Contract #: 04-0120F4
 Cty: SF/ALA Rte: 80 PM: 13.2/13.9
 File #: 69.25B

QUALITY ASSURANCE -- NON-CONFORMANCE REPORT

Reference Description: Missed MT Indications by QC on Base Metal Repairs, CB2/3AE, CB2/3AW Splices

Job Name: SAS Superstructure

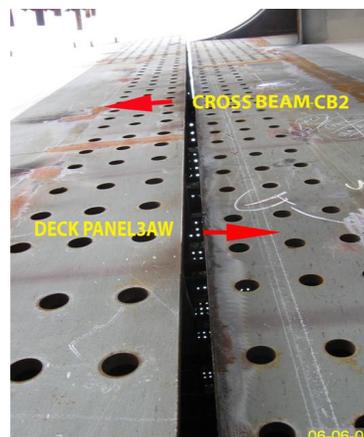
During random magnetic particle testing (MT) of base metal repairs associated with the bolted splice plate connection areas of CB2 to 3AE & 3AW, Caltrans Quality Assurance (QA) Inspector observed linear indications. The base metal repairs were performed to correct damage that resulted from removing the temporary welds holding the splice plates in place while match drilling was completed. These areas were previously tested & accepted by ZPMC Quality Control (QC) MT technicians.

Reference Description: Missed MT Indications by QC on Base Metal Repairs, @B2/3AE, CB2/3AW Splices

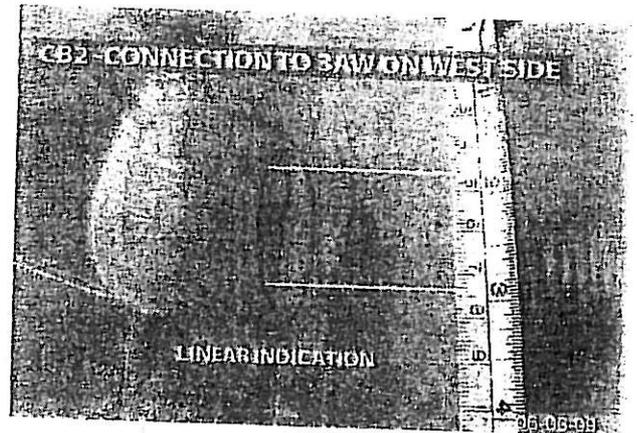
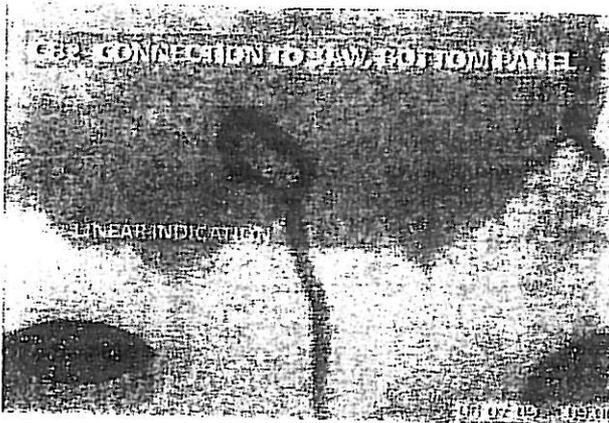
During random magnetic particle testing (MT) of base metal repairs associated with the bolted splice plate connection areas of CB2 to 3AE & 3AW, Caltrans Quality Assurance (QA) Inspector observed linear indications. The base metal repairs were performed to correct damage that resulted from removing the temporary welds holding the splice plates in place while match drilling was completed. These areas were previously tested & accepted by ZPMC Quality Control (QC) MT technicians.

Draft of Welding Discontinuity:

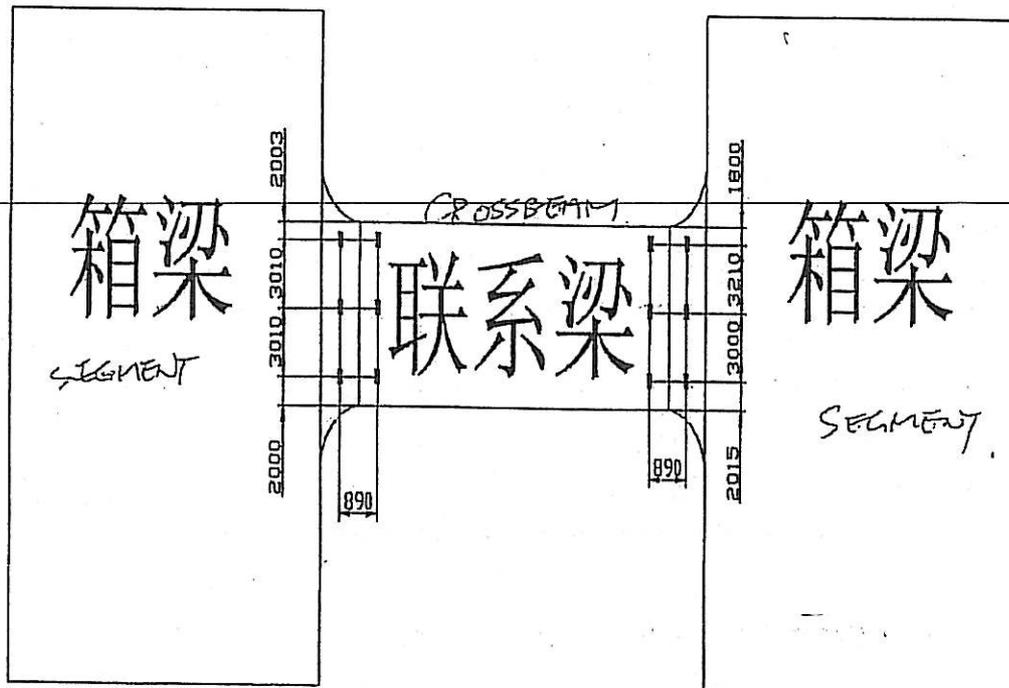
CB2, CB3联系梁在去除连接板与箱梁上点焊时, 发现伤及联系梁和箱梁的母材, 最大深度为3MM, 具体位置见下图:
After removing CB2 and CB3 strut plate tack weld, the base metal was gouged, maximum 3mm, the detail see the following draft.

Remark: blank point was base metal gouged area.

The worker operated error during removing tack welds caused base metal gouged.

1. Prepare excavation according to the approved repair WPS.
2. Grind the gouged area to a smooth and shiny finish, with tapered ends, to ensure staggered starts and stops.
3. VT and MT the repair area.
4. Preheat and weld according to the relevant repair WPS.
5. Grind the repaired area flush with base metal or the adjacent weld.
6. Perform VT and MT over 100% of the repair area.

Draft of Welding Discontinuity:

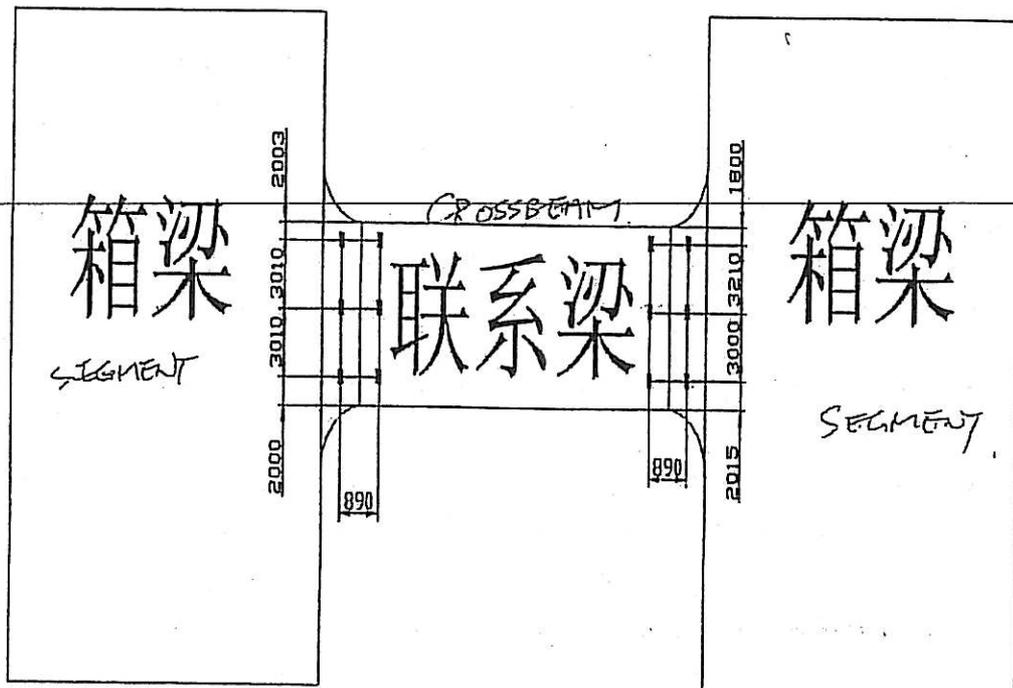
After removing CB2 and CB3 strut plate tack weld, the base metal was gouged, maximum 3mm, the detail see the following draft.

Remark: blank point was base metal gouged area.

The worker operated error during removing tack welds caused base metal gouged.

1. Prepare excavation according to the approved repair WPS.
2. Grind the gouged area to a smooth and shiny finish, with tapered ends, to ensure staggered starts and stops.
3. VT and MT the repair area.
4. Preheat and weld according to the relevant repair WPS.
5. Grind the repaired area flush with base metal or the adjacent weld.
6. Perform VT and MT over 100% of the repair area.
